**From:** Comar, Manny  
**Sent:** Monday, June 16, 2014 11:31 AM  
**To:** Hinson, Charles  
**Cc:** TurkeyCOL Resource  
**Subject:** FW: FPL Letter L-2014-158 Dated 06-04-2014: NRC RAI Letter No. 072 (eRAI 6985) Supplemental Response  
**Attachments:** OSC from PART\_05 Annex 2.pdf; OSC from PART\_05 Annex 3.pdf; OSC Description from PART\_05 Annex 3.pdf

Re: Florida Power & Light Company  
Proposed Turkey Point Units 6 and 7  
Docket Nos. 52-040 and 52-041  
Supplemental Response to NRC Request for Additional Information Letter No. 72  
(eRAI 6985) SRP Section 11.02 - Liquid Waste Management Systems

Figure C1-1 Units 6 & 7 Facility Layout

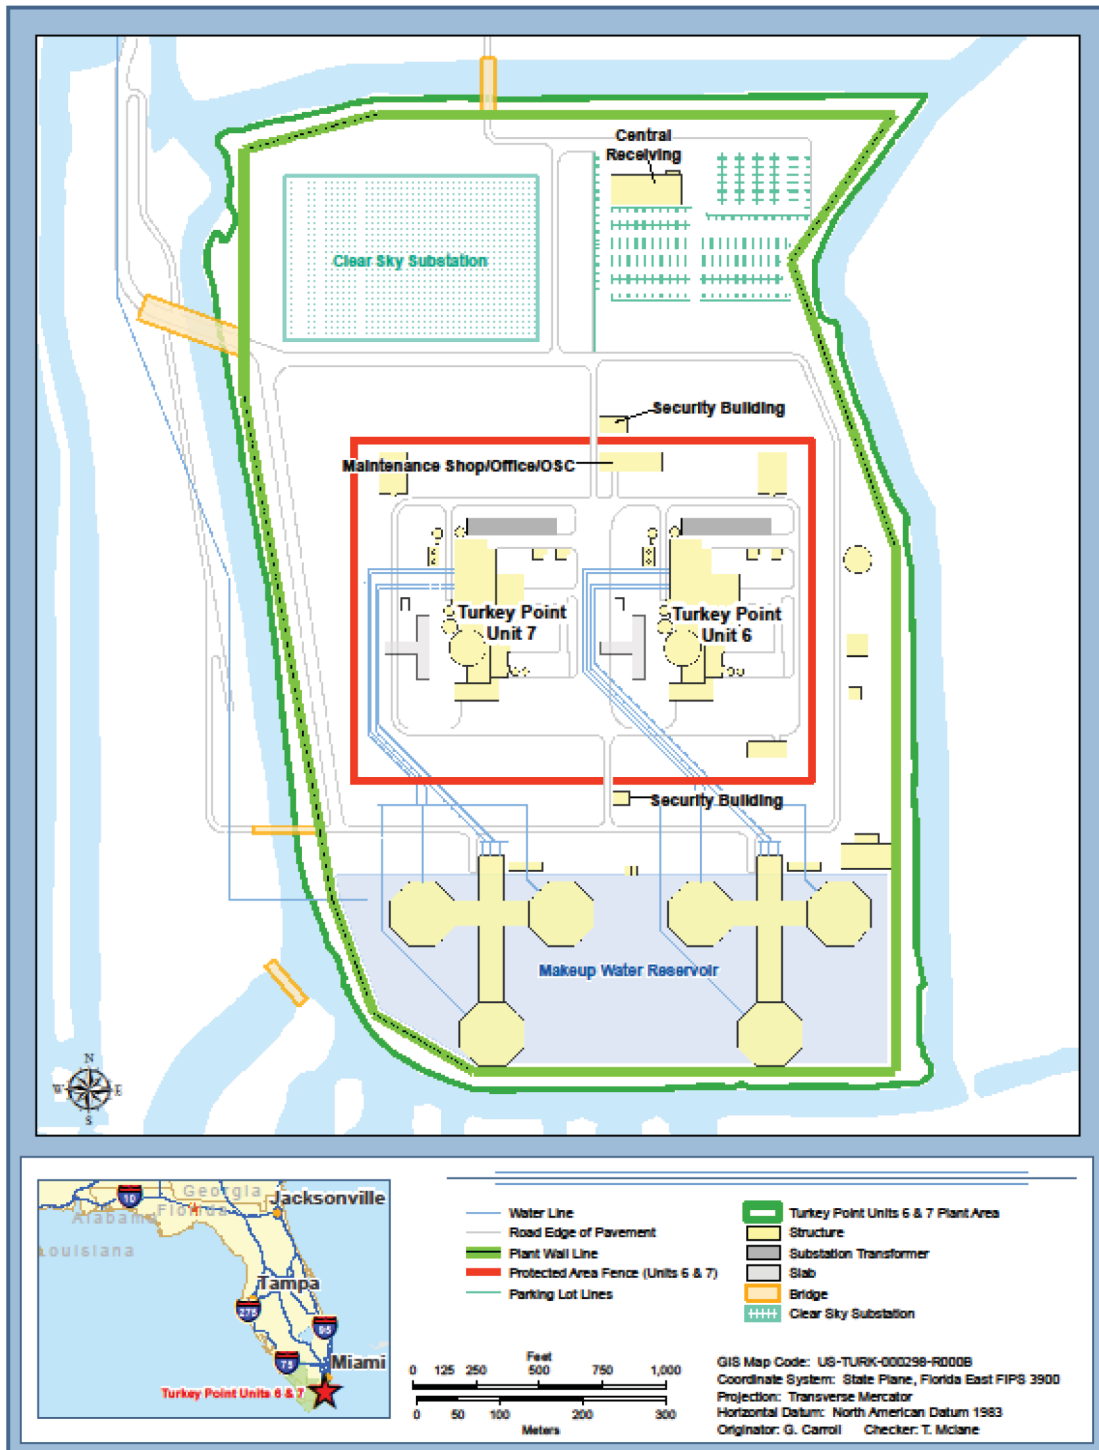
Here is a figure you can point him too. After he reviews we can discuss any other clarifications we may need. Figure C1-1 shows the Maintenance Shop/Office/**OSC** location. It is pdf p.200 of 298 in Part 5.

I left you a voice message asking if you could contact the applicant and have them tell me the location of the joint Offsite Support Center (OSC) for Units 6 and 7. The relocation of the OSC is described in Departure 18.8-1 and this states that the location of the OSC is described in the Emergency Plan. Part 2 of the Emergency Plan (page H-4) describes the operations of the OSC, but does not give the location. Can you ask the applicant and ask them if the OSC for Units 6 & 7 is shown on any figures? Thanks

The OSC is located in the Maintenance Shop/Office Building inside the Protected Area. The OSC is the location from which survey, operations, and repair teams are dispatched into areas of the plant and is the staging area for individuals who may be assigned to first aid, search, survey, rescue, repair, and corrective action teams.
